**Scientific and economic objections
to
unconventional drilling at
Broadford Bridge, West Sussex**

Emeritus Professor of Geophysics, University of Glasgow

Talk at Pulborough

This is an annotated and referenced version of the talk I gave at Pulborough Village Hall on 30 April 2017.

Kimmeridge OGL's plans for Broadford Bridge

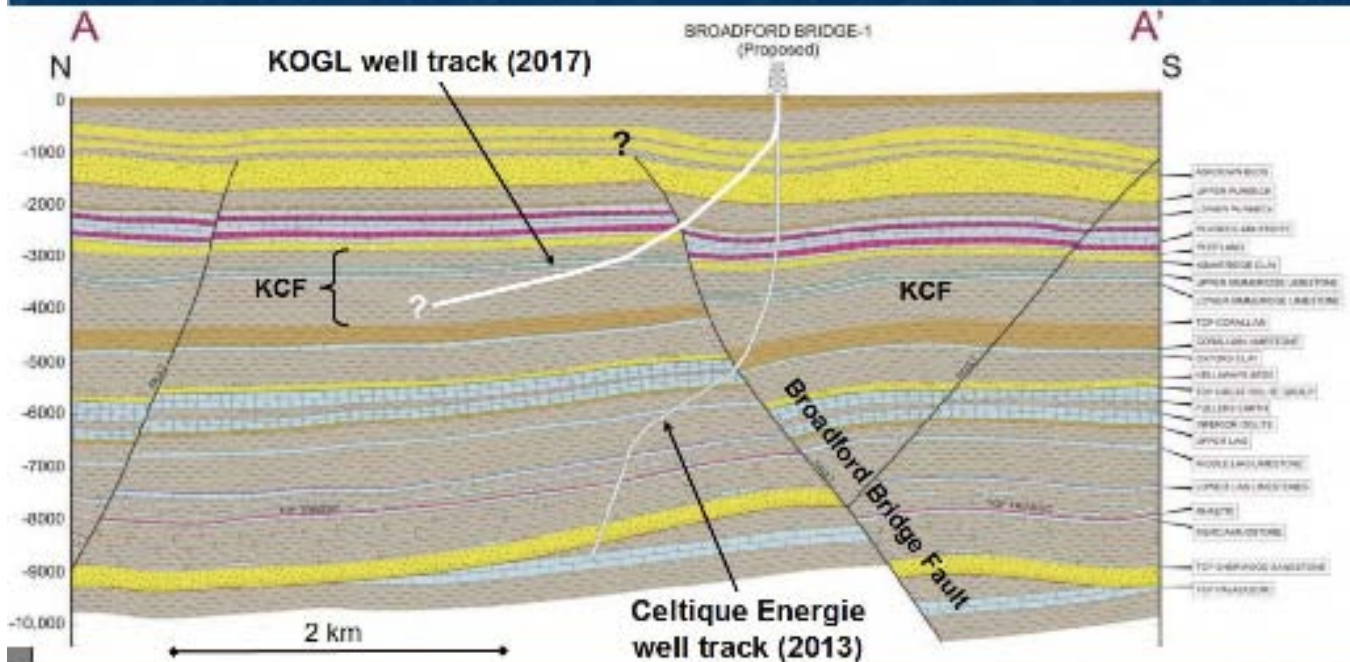
KOGL has simply copied the prognostic geological column from Celtique Energie's proposal on the left, and added slightly new depth figures and some notes on the right. This is highly misleading.

Celtique predicted that it would cross the Bradford Bridge Fault at about 5000 ft (scale at left-hand side), so that part of the geological succession is missing (lower red box). But KOGL plans to drill across the same fault at much shallower depth (note in red box on right). So geological layers should be missing from the right-hand column, instead of being a simple copy of the Celtique column on the left.

The proposal by KOGL as presented makes no geological sense, and should therefore be rejected.

Seismic line 500 m west of, and parallel to, proposed deviated well

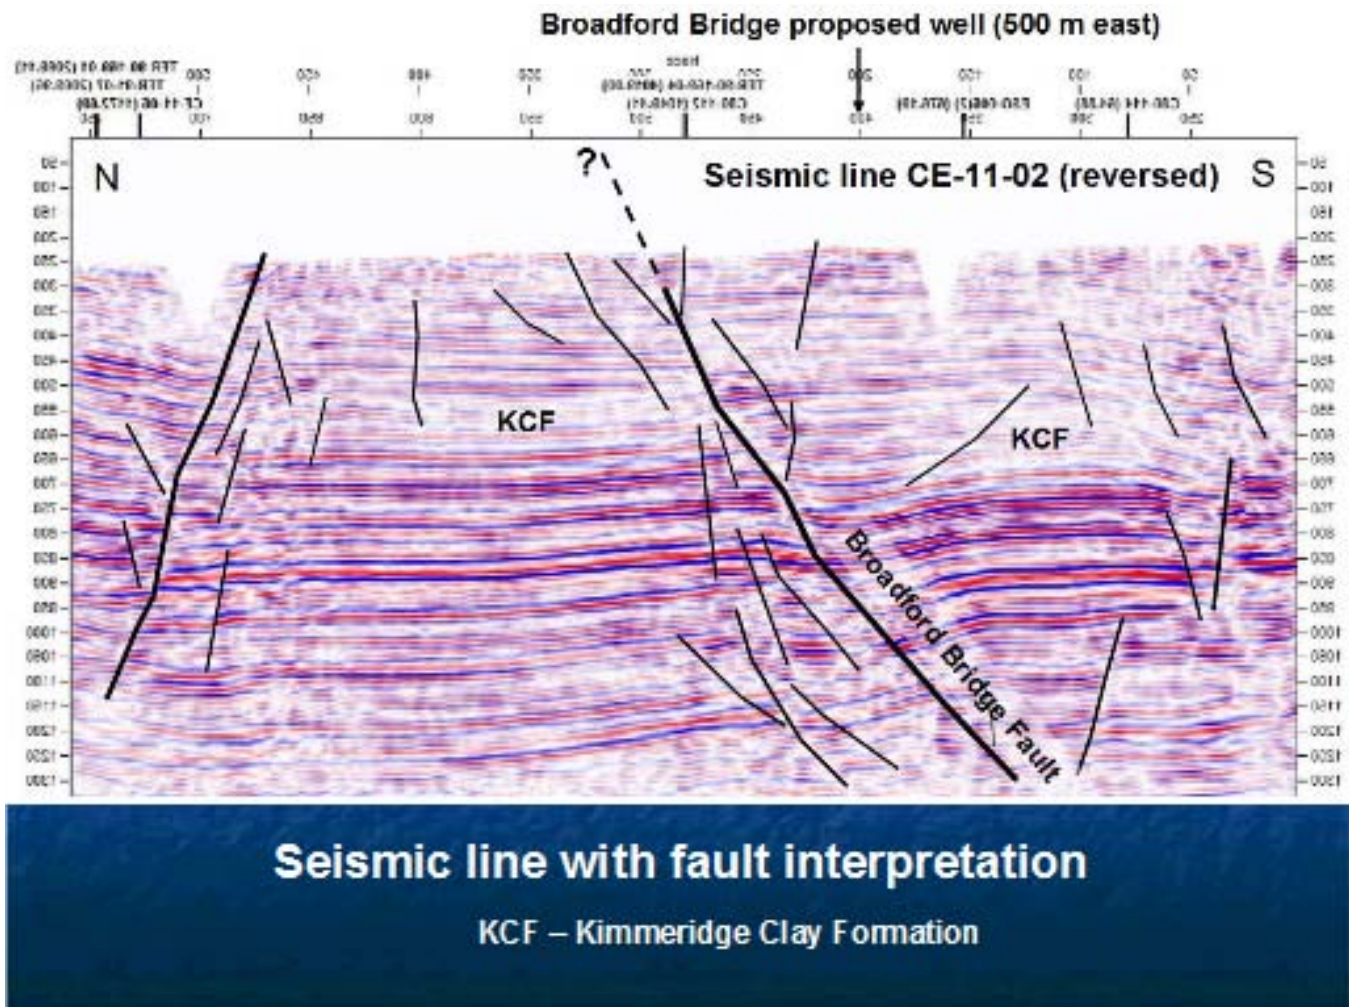
The geology is inferred from 2D seismic reflection images like this one, lying 500 m west of the proposed drill site. It is akin to a geological cross-section, except that the vertical scale is in milliseconds of down-and-back reflection time, not depth.

I have added fault interpretation to the raw seismic data, with thicker lines indicating bigger faults. The main Broadford Bridge Fault may extend up to the surface, but has not been mapped at outcrop (i.e. at the surface), and, as can be seen, there is no seismic image shallower than 250 ms (about 300 m depth below sea level).

KOGL plans to drill obliquely into the Kimmeridge Clay Formation (KCF) on the north side of the Broadford Bridge Fault. The micrite limestone layers are too thin to show up on the seismic image.

Even if the drilling were to be carried out along the vertical plane of this section, it can be seen that there are many uncertainties in identifying both the faults and the geological layering. For KOGL to drill 500 m away from this line is irresponsible.
